SALEM NUCLEAR GENERATING STATION, UNIT NO. 1

AMENDMENT TO FACILITY OPERATING LICENSE

Amendment No. 13  
License No. DPR-70

SAFETY EVALUATION BY THE OFFICE OF NUCLEAR REACTOR REGULATION  
SUPPORTING AMENDMENT NO. 13 TO FACILITY OPERATING LICENSE DPR-70

FIGURE 6.2-1. OFFSITE ORGANIZATION FOR FACILITY MANAGEMENT AND TECHNICAL SUPPORT

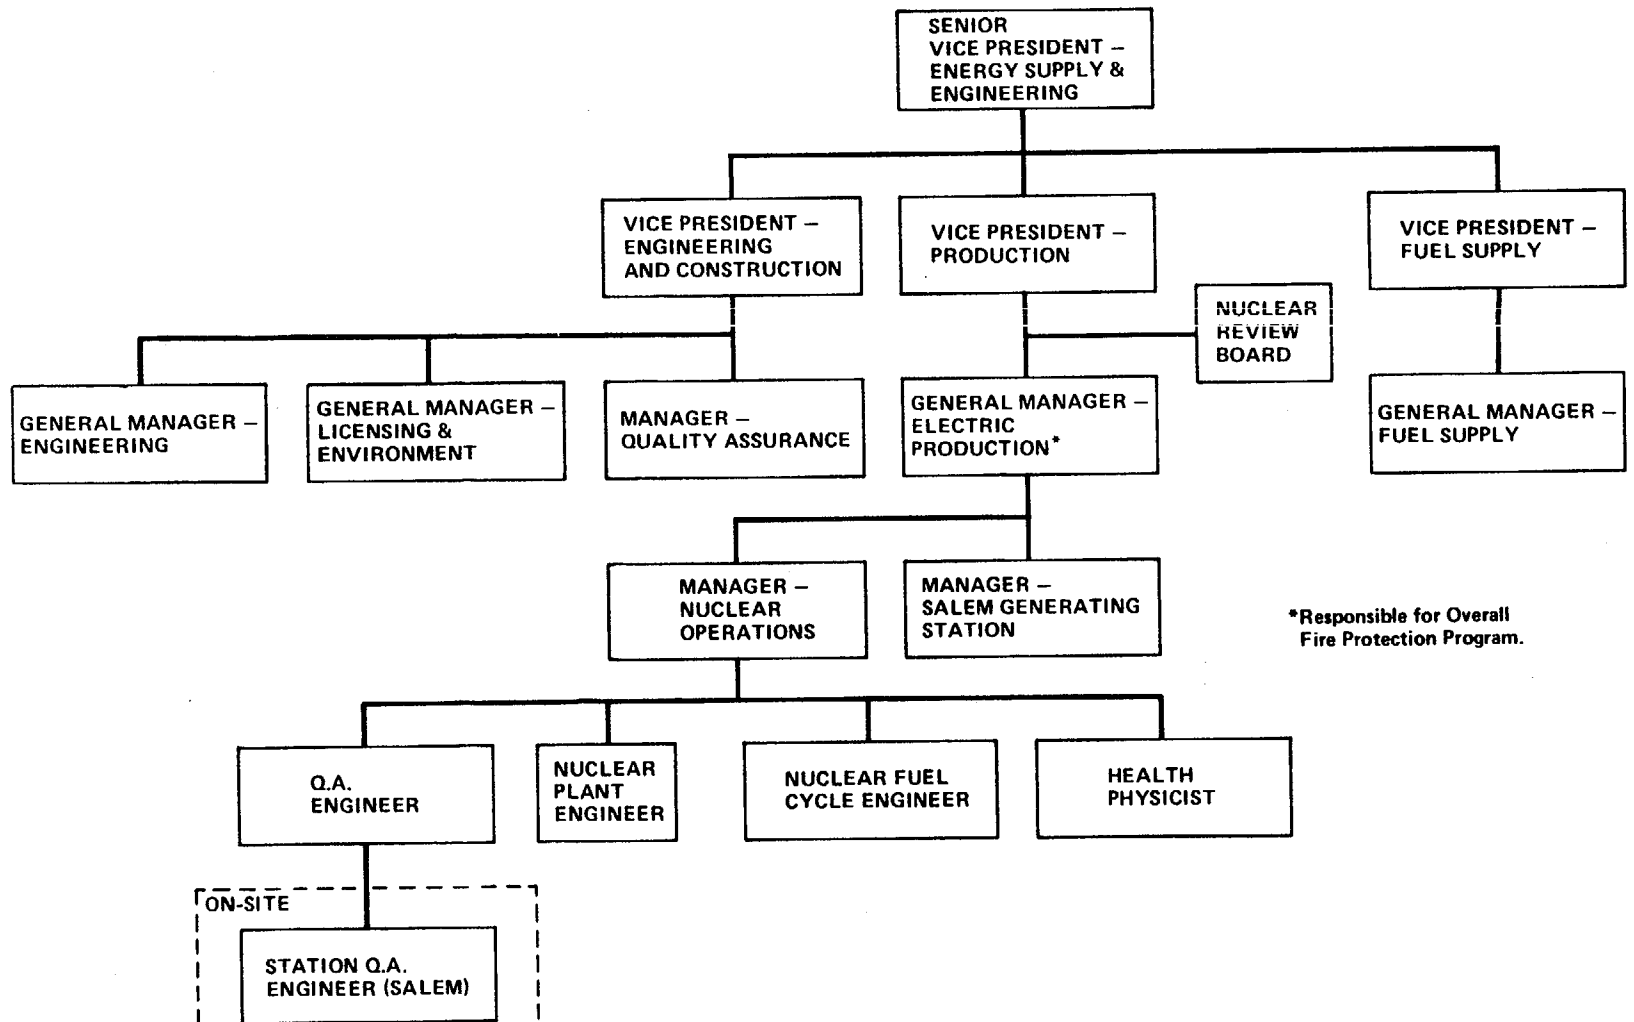
The licensee has proposed to revise the organization charts in Figures 6.2-1 and 6.2-2 and Figure 5.2-1 of the Appendix A and Appendix B Technical Specifications, respectively, to reflect recent changes in the station and offsite organizations and to add a note with regard to Senior Reactor Operator (SRO) requirements. Specifically, these changes are:

1. The Assistant to Manager at the Salem Station is now responsible for administration of the Safety and Security Programs in addition to the Training Program;
2. The reassignment of the Station Quality Assurance Engineer from reporting to the Manager - Salem Generating Station to reporting to the Quality Assurance Engineer;

and do not involve revisions to personnel qualification requirements other than those allowed by ANSI N 18.1, as applicable. In addition, the changes to create the position of Quality Assurance Engineer in the offsite organization and to require that the Station Quality Assurance Engineer report to that individual rather than to the Manager - Salem Generating Station is acceptable in that the Quality Assurance Engineer position is a senior-level position within the offsite organization reporting to the Manager - Nuclear Operations.

We have evaluated the licensee's requests to update the offsite and station organizational charts to reflect recent organization changes and have concluded that these changes are administrative in nature

FIGURE 6.2.2 FACILITY ORGANIZATION - SALEM GENERATING STATION

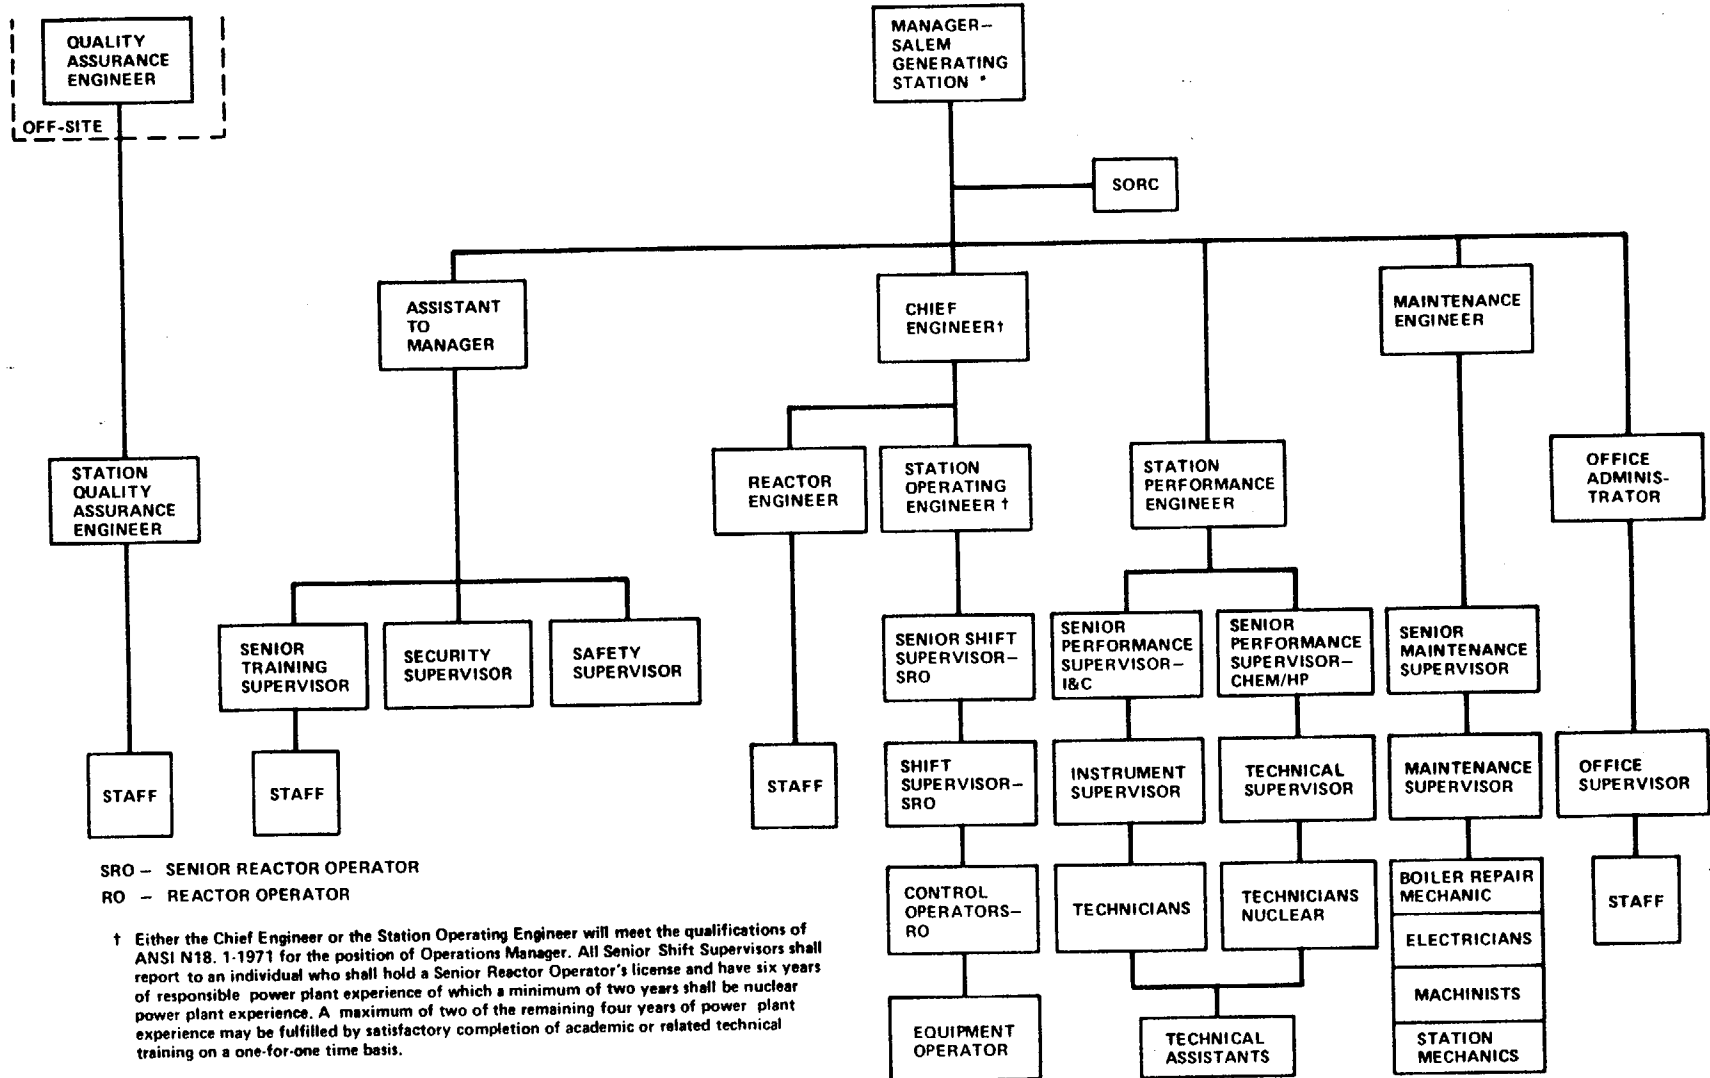
† Either the Chief Engineer or the Station Operating Engineer will meet the qualifications of ANSI N18.1-1971 for the position of Operations Manager. All Senior Shift Supervisors shall report to an individual who shall hold a Senior Reactor Operator's license and have six years of responsible power plant experience of which a minimum of two years shall be nuclear power plant experience. A maximum of two of the remaining four years of power plant experience may be fulfilled by satisfactory completion of academic or related technical training on a one-for-one time basis.

3. Either the Chief Engineer or the Station Operating Engineer will meet the qualifications of ANSI N18.1-1971 for the position of Operations Manager. All Senior Shift Supervisors shall report to an individual who shall hold a Senior Reactor Operator's license and have six years of responsible power plant experience of which a minimum of two years shall be nuclear power plant experience. A maximum of two of the remaining four years of power plant experience may be fulfilled by satisfactory completion of academic or related technical training on a one-for-one time basis.
4. The implementation of the environmental surveillance programs is now the responsibility of the Licensing and Environment Department in the Engineering and Construction Department rather than the Nuclear Licensing and Environmental Studies Group in the Mechanical Division of the Engineering Department.

FIGURE 5.2-1  
OFFSITE ORGANIZATION FOR FACILITY  
MANAGEMENT AND TECHNICAL SUPPORT

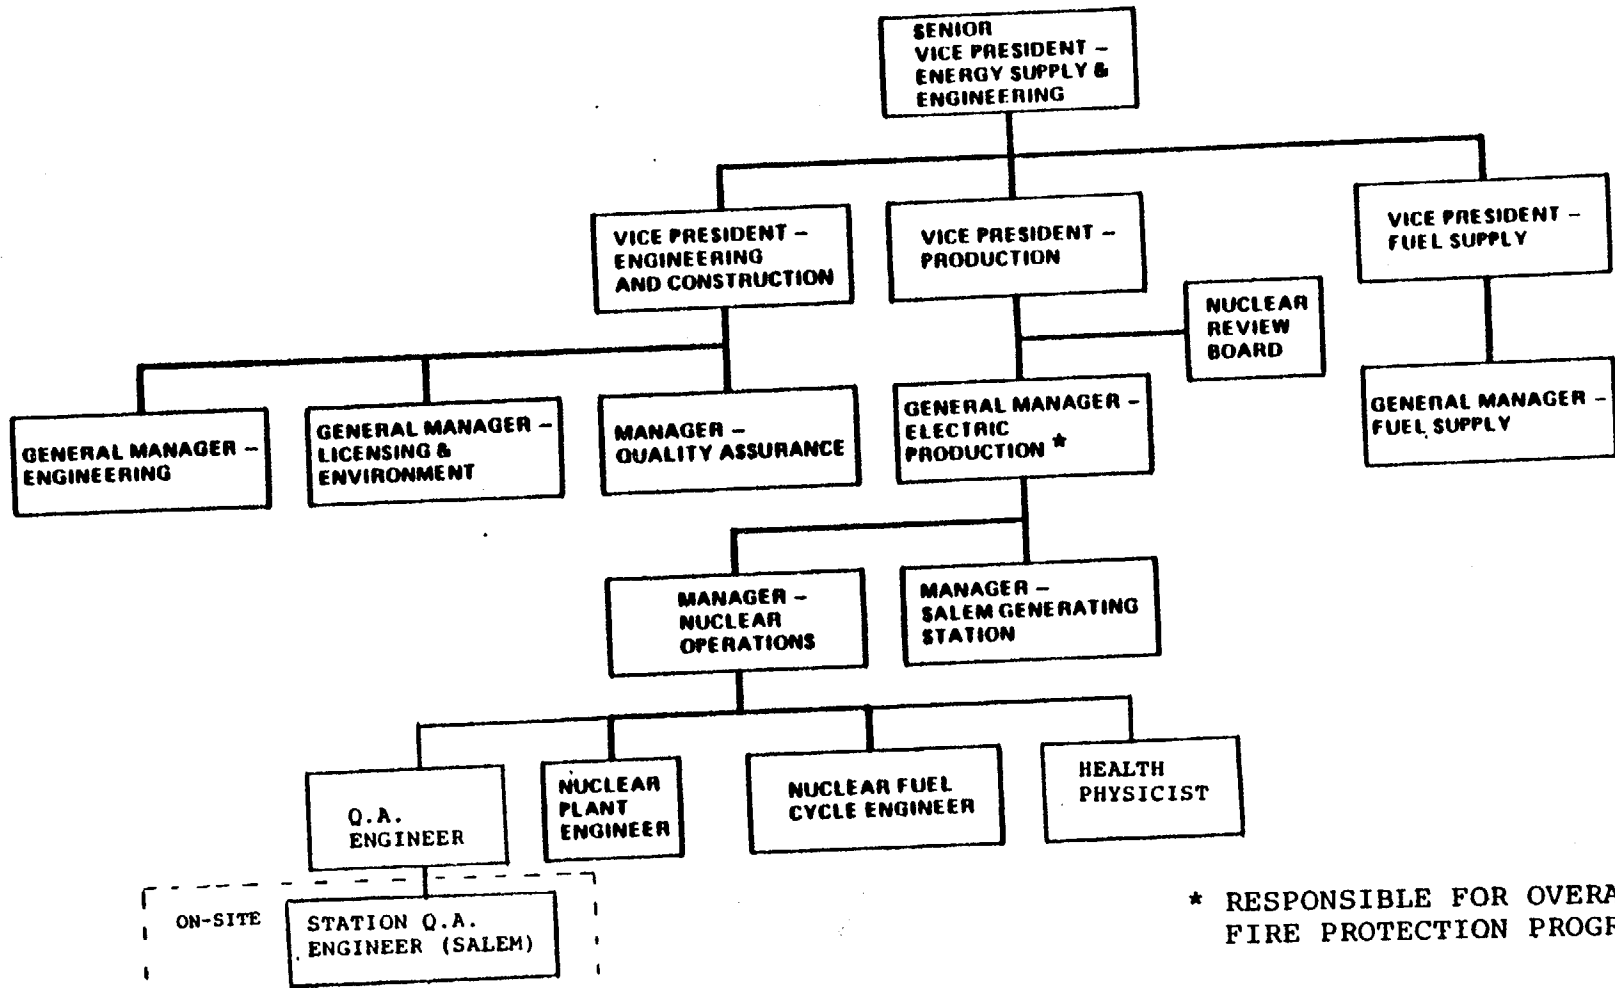
5.2.1 Figure 5.2-1 identifies the corporate relationship between the Licensing and Environmental Department and the station Manager and also shows the organization of the Licensing and Environment Department. Figure 6.2.2 of the Radiological Safety Technical Specifications identifies the Production Department Station Organization.

Since the implementation of the environmental surveillance program is now the responsibility of the Engineering and Construction Department rather than the Mechanical Division of the Engineering Department as discussed above, Figure 5.2-2 in the Appendix B Technical Specifications which identifies the organization of the latter department, is no longer necessary and is being removed by this amendment. In addition, Figure 5.2-3 in the Appendix B Technical Specifications which identifies the Salem Station organization is a duplication of Figure 6.2-2 of the Appendix A Technical Specifications and is therefore being removed by this amendment, with a reference to Figure 6.2-2 being added in Section 5.2.1 of the Appendix B Technical Specifications.
